Subject: Elevator Linkage at the base of the stick

Affected: Glider-Model: H 301
H 301 B

Reason: All Works Nos.
Failure of a Linkage

301-41-4/2

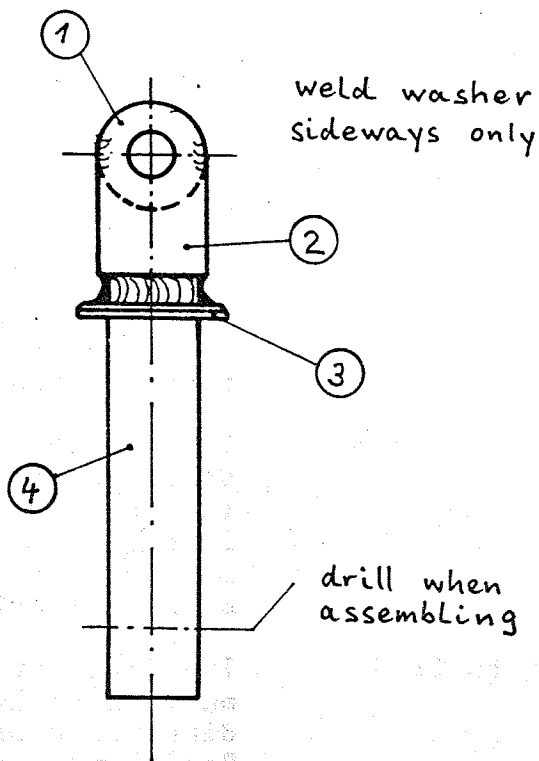
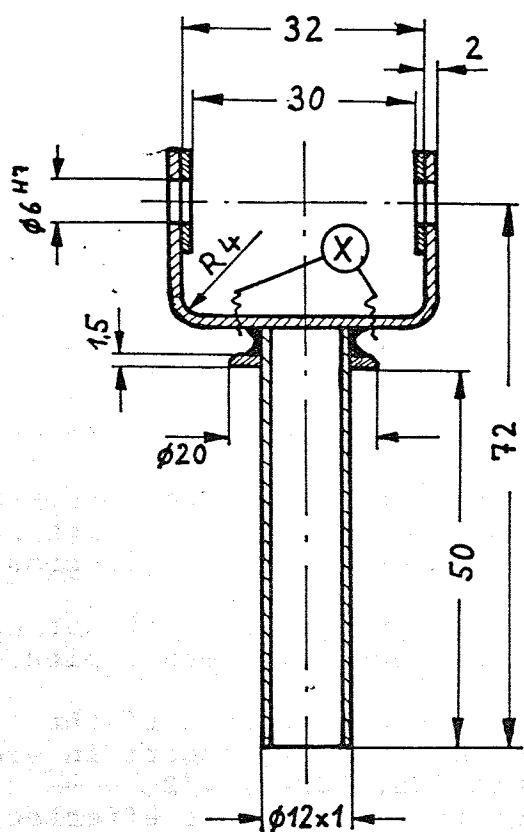
Action 1: The Elevator Linkage at the base of the stick (see modified drawing No. 301-41-4/2) must be inspected carefully by means of a magnifying glass (magnification at least 5x) for possible cracks near the welded seam. This inspection must be made immediately and again following the application of high loads to the glider (e.g. hard landing or ground loops). If cracks are found the glider must not be flown until the defective part has been replaced.

Action 2: The Elevator Linkage at the base of the stick must be replaced by a modified part in accordance with drawing No. 301-41-4/2 Replacement must in all cases be effected until November 1st 1980.

(X) Position of possible cracks on original Elevator Linkage

- ① washer (2x) St $\varnothing 14 \times \varnothing 5,5 \times 1$
- ② frame 1.7734.4 76,5 x 14 x 2
- ③ washer St $\varnothing 20 \times \varnothing 12 \times 1,5$
- ④ tube 1.7734.4 $\varnothing 12 \times 1 \times 56$

heat-treatment after welding: Tempering in controlled atmosphere
1 hour at 550°C
